LAND AND ENVIRONMENT COURT OF NSW FILED ON 23 MAR 2018	
	INT

AGREEMENT BETWEEN THE PARTIES

Court Land and Environment Court of New South Wales
Class 1
Case number 2017 / 268600

NSWLEC Proceedings No. 2017 / 268600

Plan No.
SY170226C603
File Ref.
SY170226C600-B.dwg
SHEET 3 OF 6 SHEETS
REV.
B

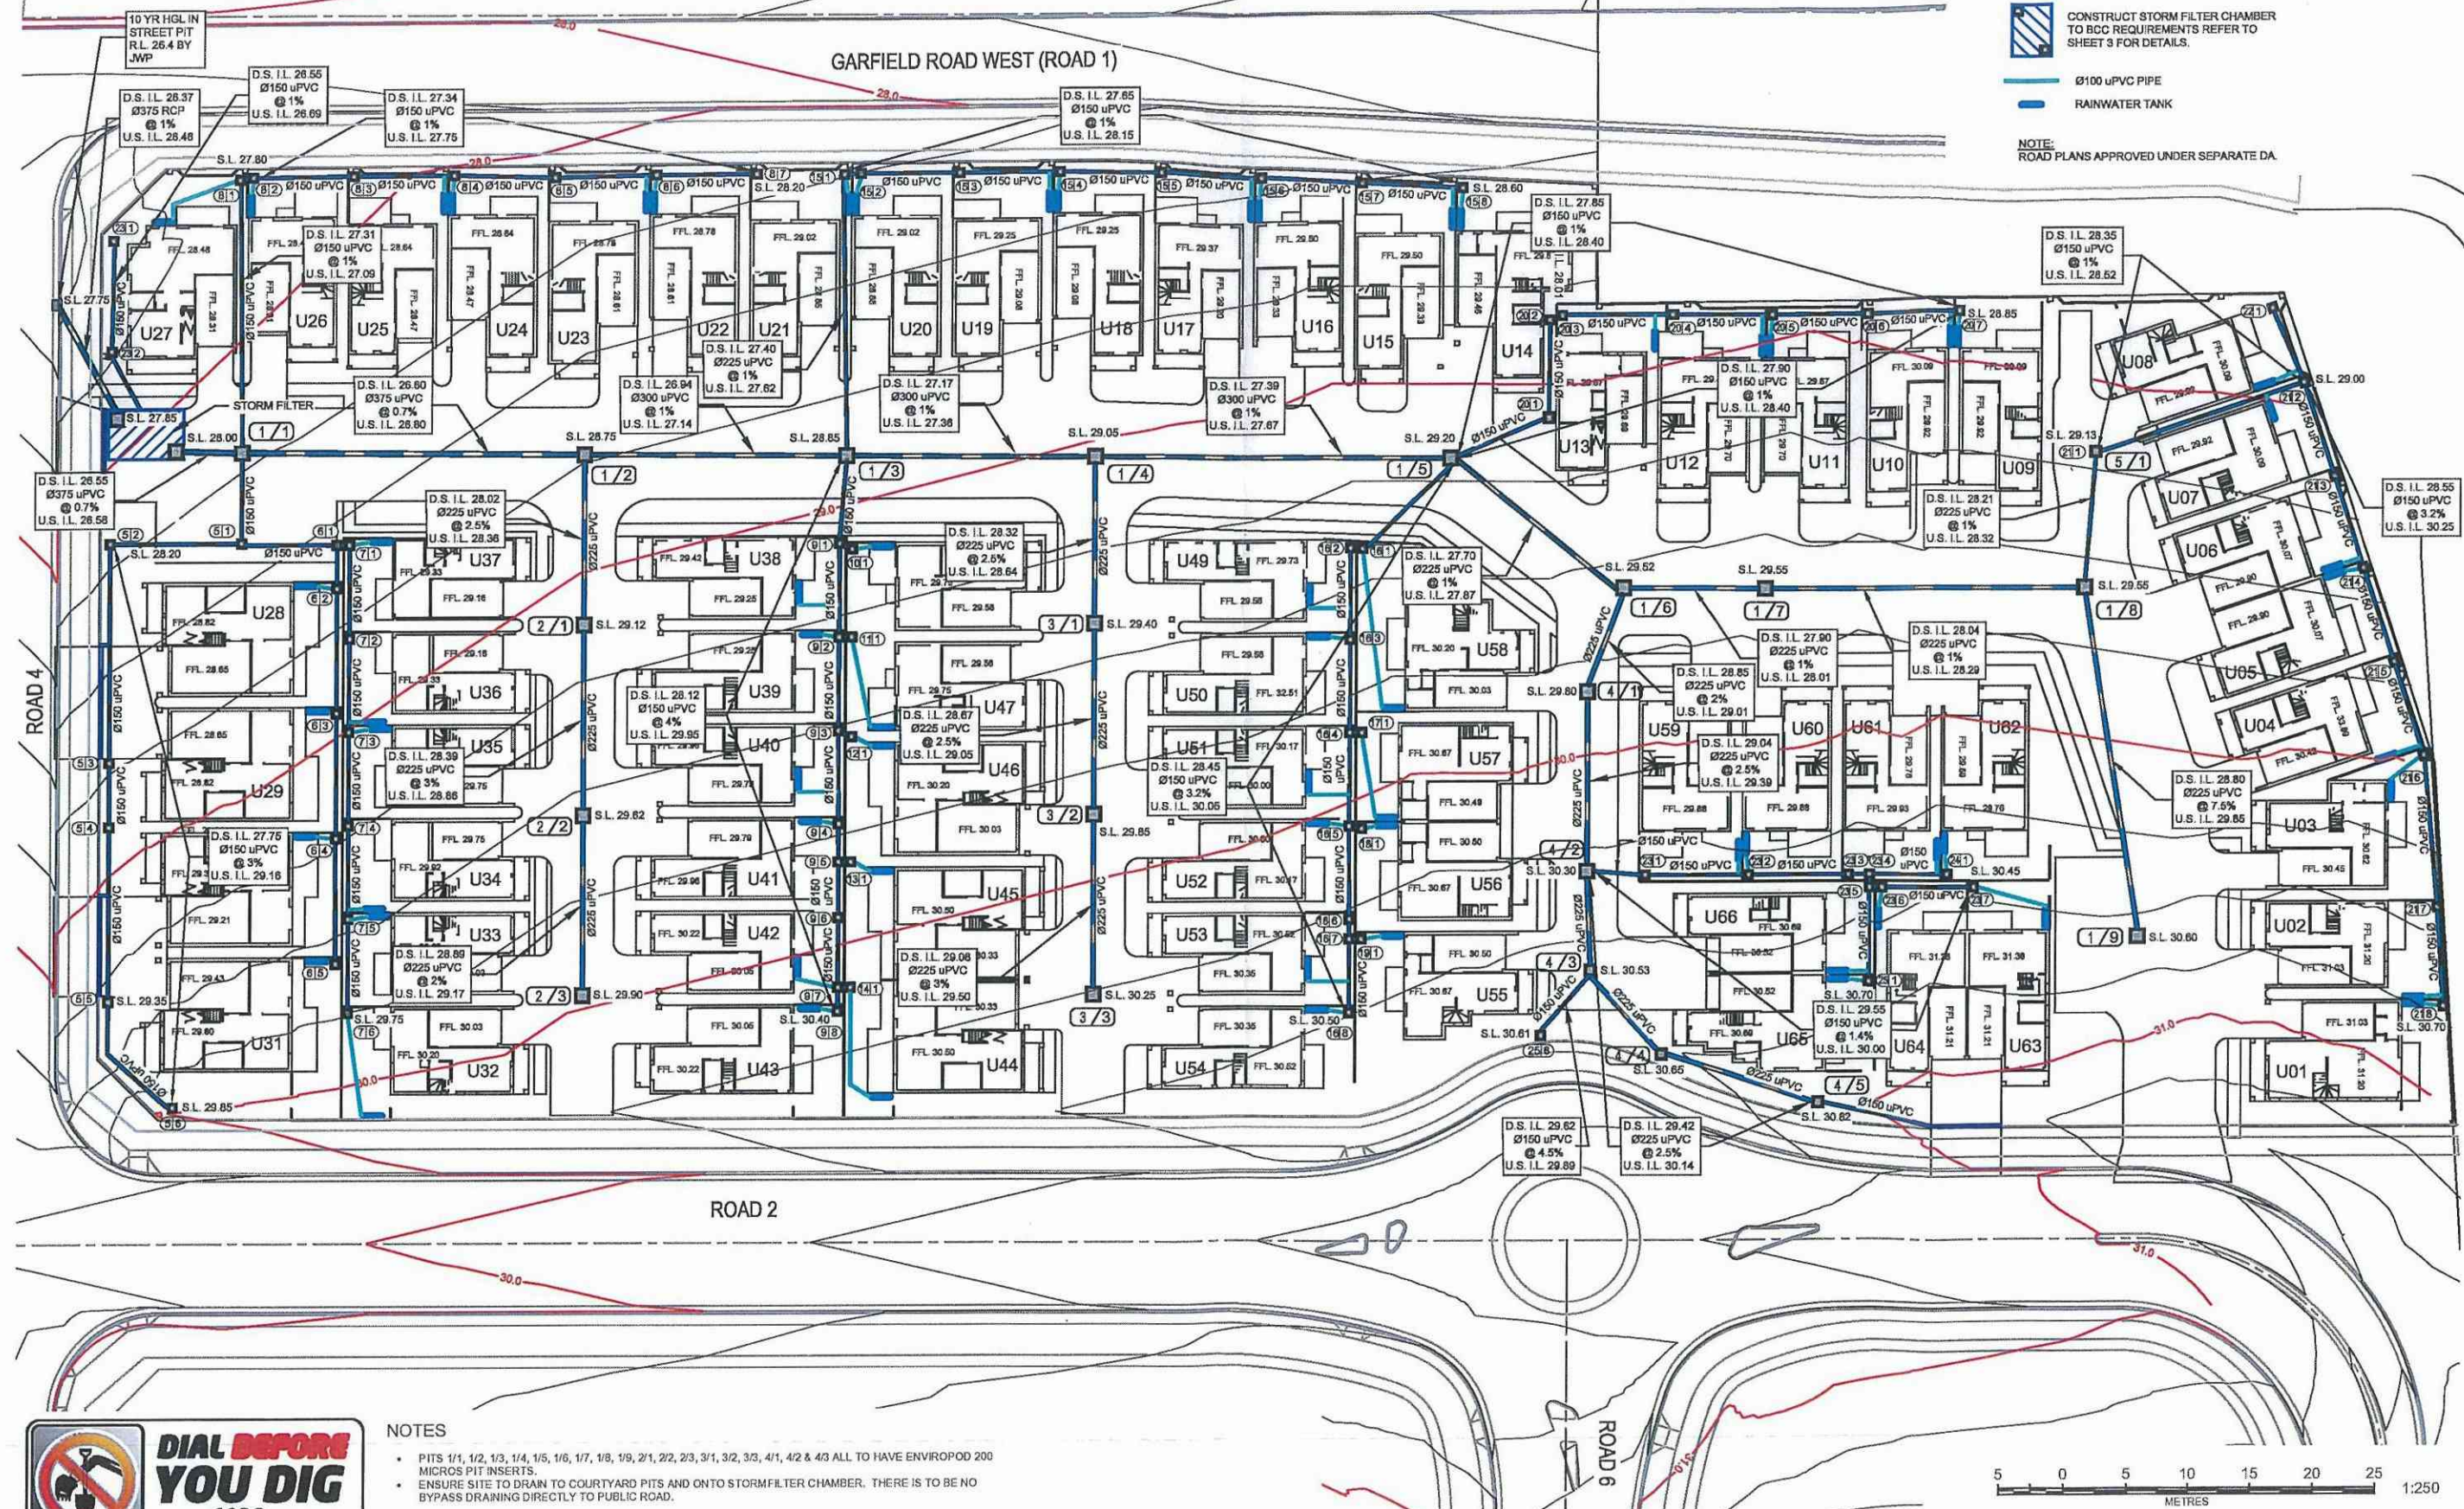
- ii. Reposition the grates for the Stormfilter chambers to ensure the access points are all clear of the baffles.
- iii. On Dwg Nos SY170226C600 Rev B renumber the first Sheet 3 as Sheet 2.

- iv. On Dwg Nos SY170226C600 Rev B new Sheet 2 amend note at bottom to include an Enviropod at pit 5/1.
- v. On Dwg Nos SY170226C600 Rev B new Sheet 2 provide minimum 150 mm kerbs along the rear boundaries of units 1 to 27.

- vi. On Dwg Nos SY170226C600 Rev B new Sheet 2 provide a swale or raised planter box along the front boundaries of units 27 to 31.
- vii. On Dwg Nos SY170226C600 Rev B Sheet 3 amend the water quality table to show 19 Enviropods.

Plan No.
SY170226C702
File Ref.
SY170226C700-B.dwg
SHEET 2 OF 6 SHEETS

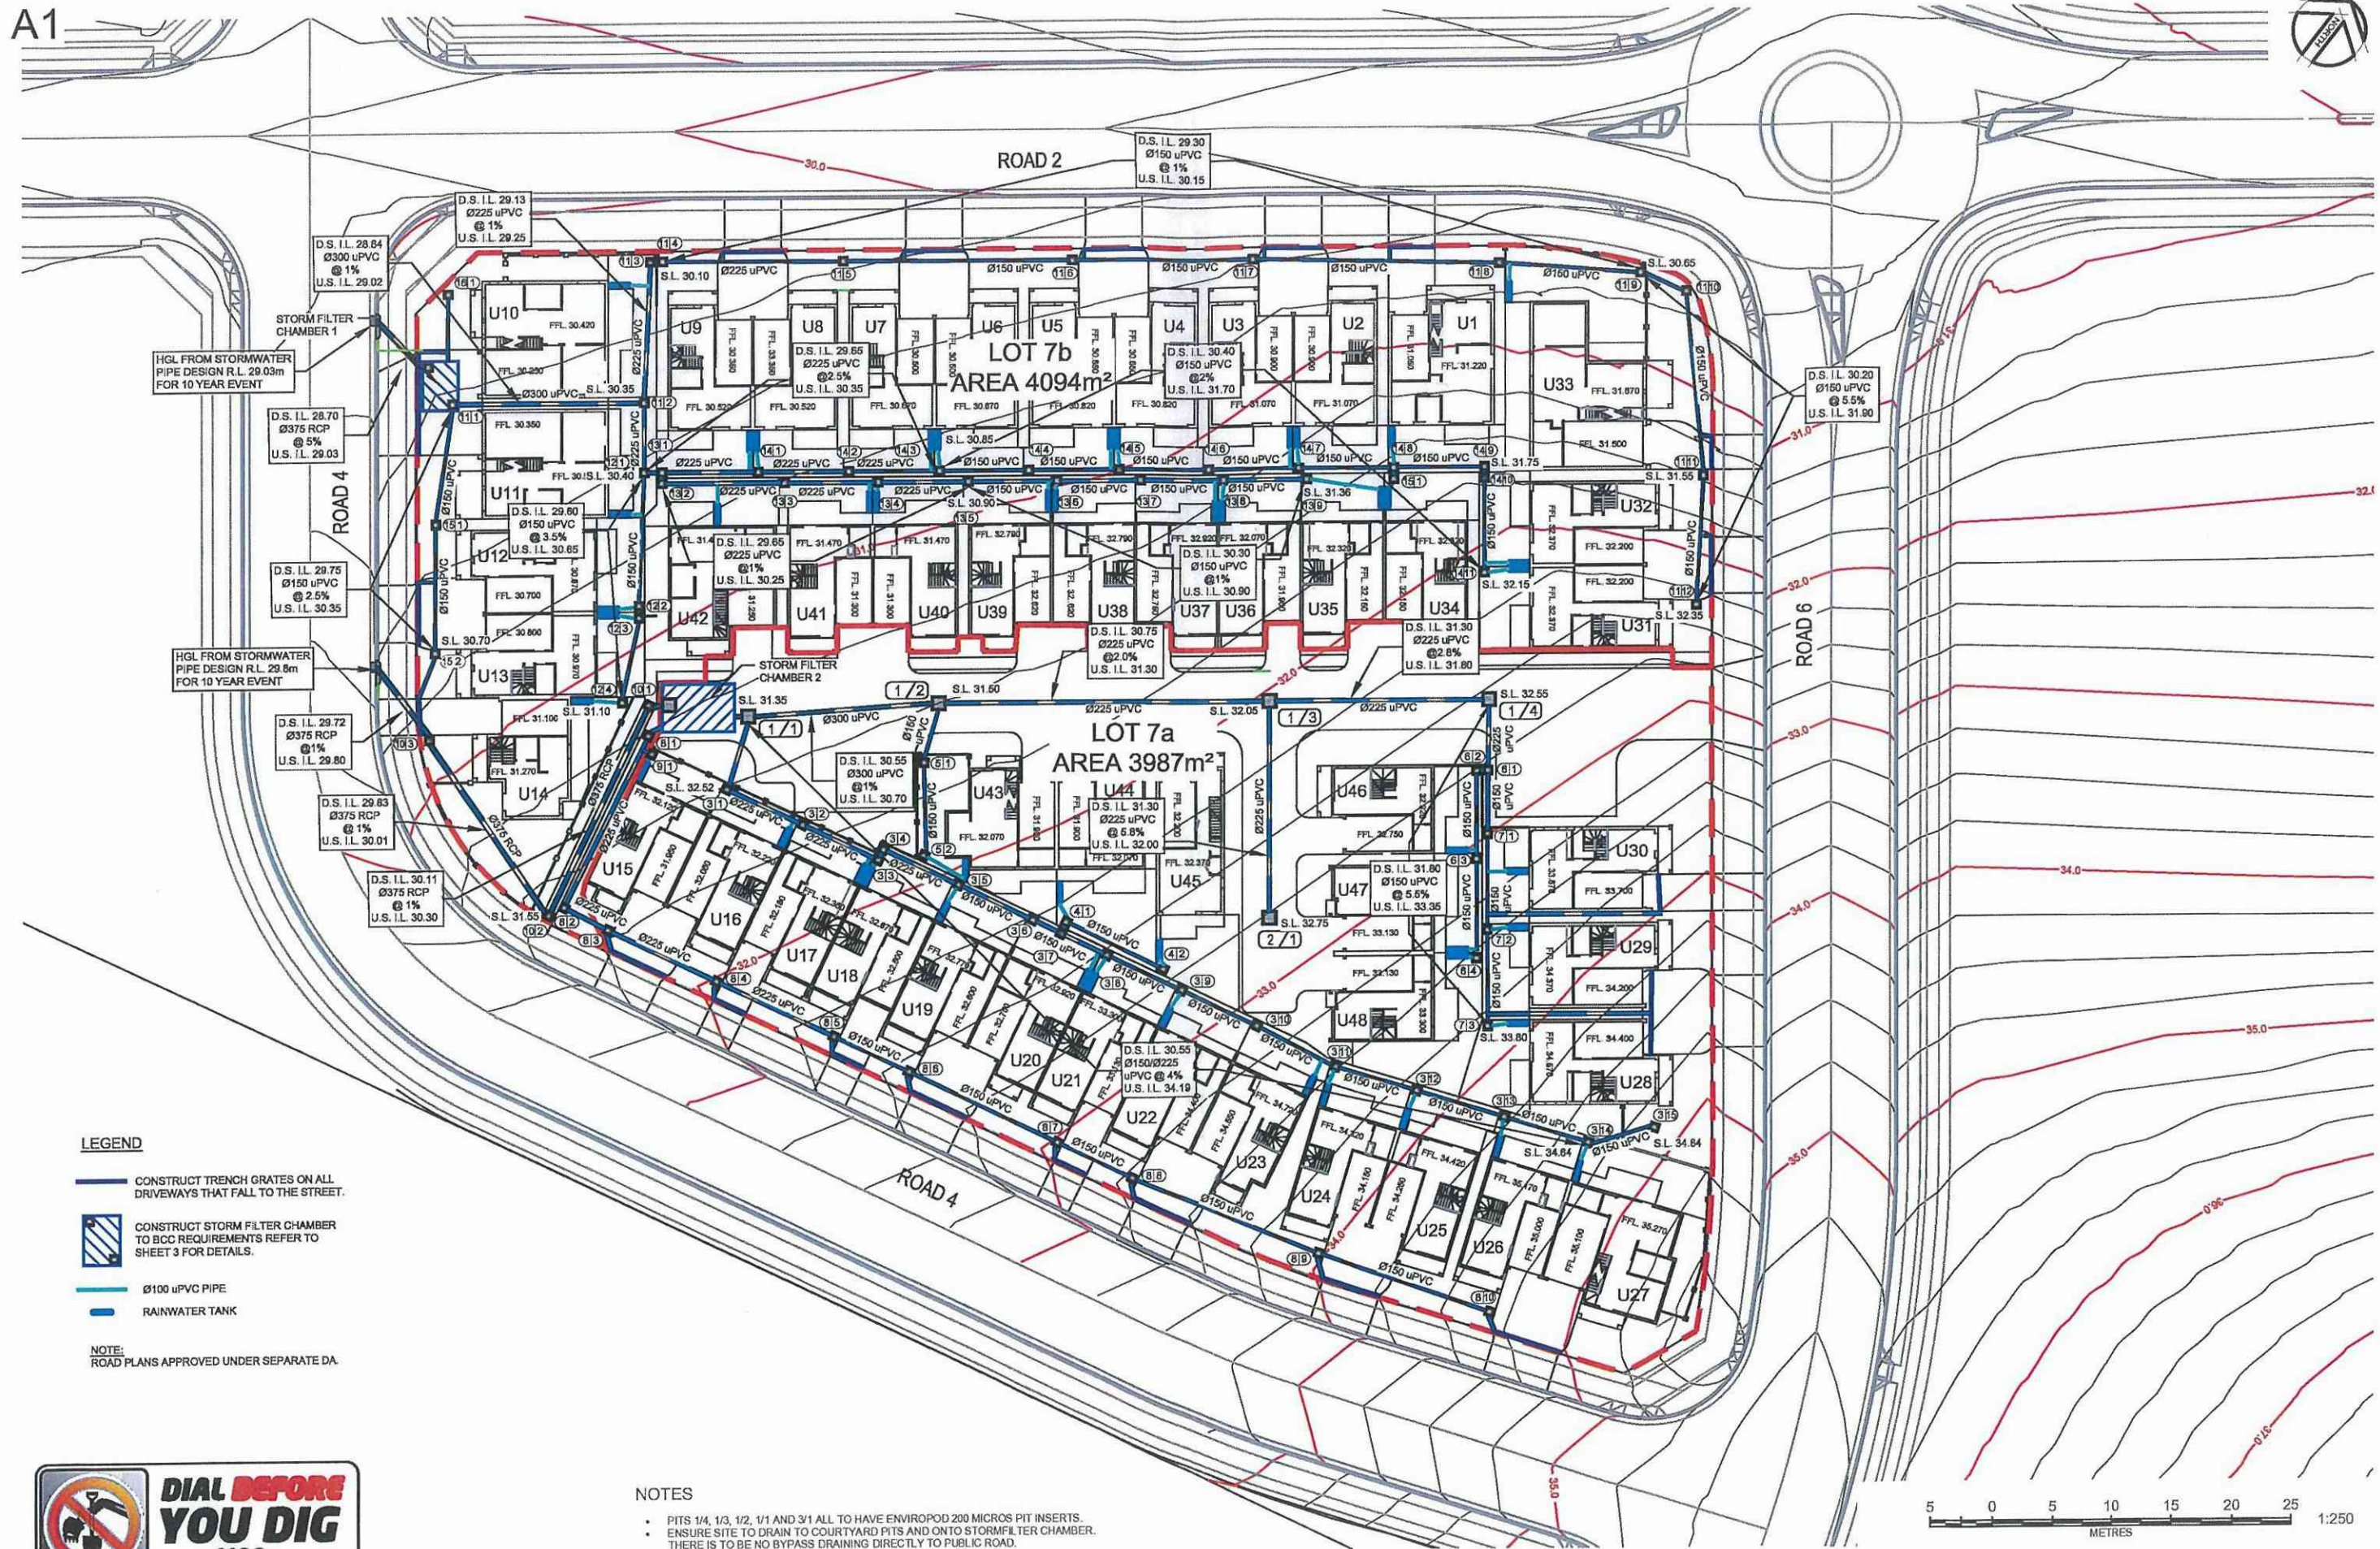
- viii. On Dwg Nos SY170226C700 Rev B Sheet 2 show minimum 150 mm trench grates in the legend.
- ix. On Dwg Nos SY170226C700 Rev B Sheet 2 provide a depressed (by minimum 100 mm) inlet pit in the front yards of units 16 to 27 repositioned closer to the front boundary and a minimum of 2.5m away from the driveway to better collect surface flows.

- x. On Dwg Nos SY170226C700 Rev B Sheet 2 redirect all roof water from the front (south) of units 34 to 42 to the rainwater tank at the rear to match the catchment boundary.

- xi. On Dwg Nos SY170226C700 Rev B Sheet 2 amend note at bottom to include Enviropods at pit 2/1 not 3/1.
- xii. On Dwg Nos SY170226C700 Rev B Sheet 3 Stormfilter Chamber C2 appears substantially drowned by the downstream tailwater level of 29.8 however the levels within the tank and at the surface may be transposed between tanks and require amendment to the naming of C1 and C2 on this plan.
